1963 - 1965 Corvette: Service Bulletin: Air Gaps - Corvette Folding Top-To-Body Panel

Subject: Air Gaps - Corvette Folding Top-To-Body Panel

Source: Chevrolet Technical Service Bulletin

Bulletin Number: TSB #1097, Section I

FIGURE 1 - REAR BOW WEATHER SEAL DETAILS

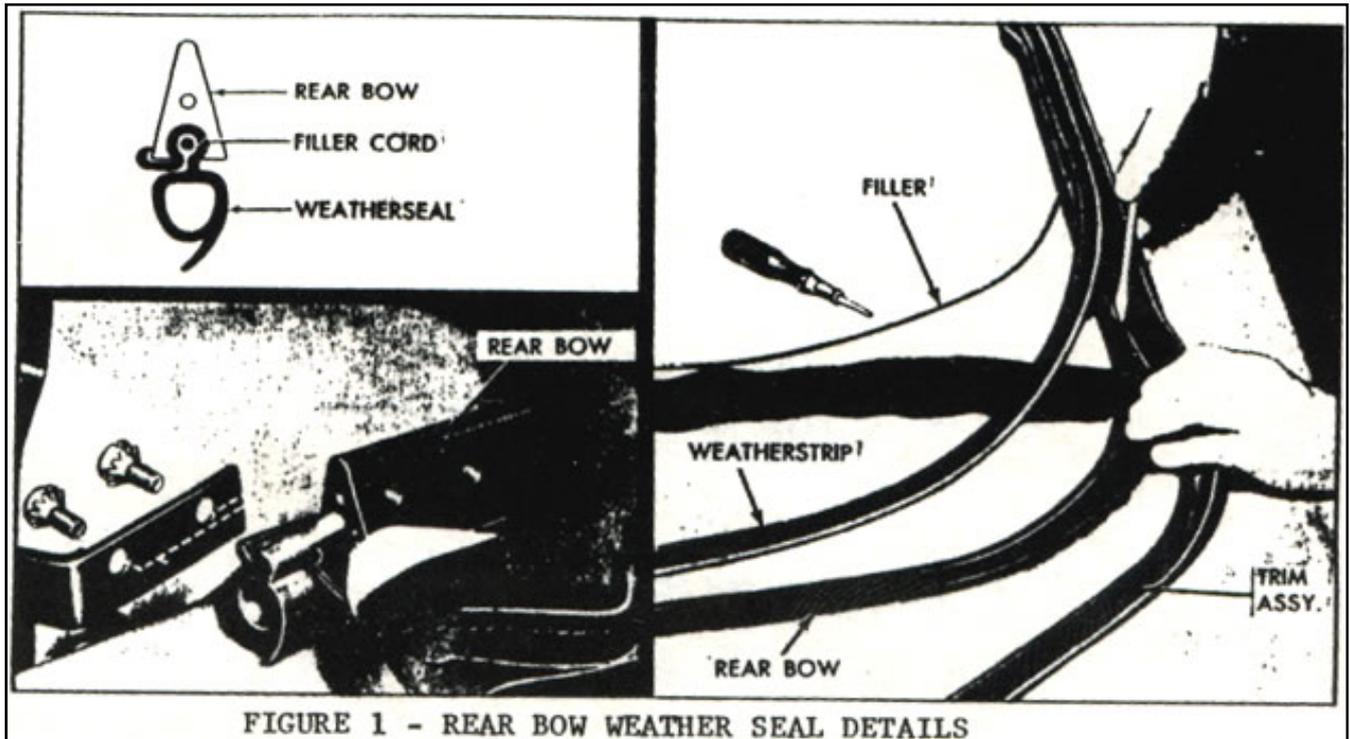
Corvettes, with folding top, may exhibit excessive gaps between rear bow weatherstrip and body panel in right and left rear quarter areas. These gaps are frequently sufficient to permit objectionable air and water entry and may be encountered on 1963-64 and early 1965 units.

A new weatherstrip which incorporates a seal with 1/4" greater height entered production effective with Serial #S108326.

The rear bow weatherstrip is retained in the bow by the installation of a filler cord which causes the upper bead of the weatherstrip to expand within the retainer channel (Figure 1).

Field complaints on this condition can be corrected by installation of the new weatherstrip, Part No. 3873761, per attached instructions.

1. Remove the weather seal by first removing the filler cord and then pulling the seal from the retainer channel of the bow.
2. Install the new seal by starting at the middle of the bow and the middle of the seal and work outward in both directions. The center portion of the seal should be installed dry to anchor the seal while installing the remaining portions. Apply liquid soap or silicon spray to the top of the seal to aid installation. Lubricate and work with no more than 12" section of the seal at a time, alternately from right to left side.
CAUTION : Do not stretch the weatherstrip on installation as this will cause distortion and poor sealing.
3. Lock the weatherstrip by installing the filler cord.
